Hard to fill fuel due to frozen filler pipe

REF NO: TJ 34215.3.0	ISSUING DEPARTMENT: Technical Service	CAR MARKET: United States and Canada		
3 US 7	PARTNER: 7510 Volvo Car USA	ISSUE DATE: 2019-03-25	STATUS DATE: 2019-04-02	
FUNC GROUP: 2340	FUNC DESC: Fuel tank, fuel lines, evaporator svstem	Page	1 of 3

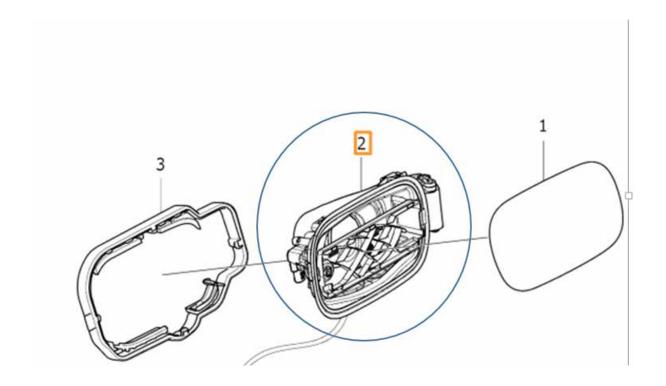
If customer complains about difficulties to refuel due to frozen filler pipe, please follow advise under "service".

Replace the fuel hatch according to VIDA. New fuel hatch was released 2018w40(90 cluster) with new sealing concept. See attachment.

*New fuel hatch for XC60, V60 and V60CC was released 2019w11.
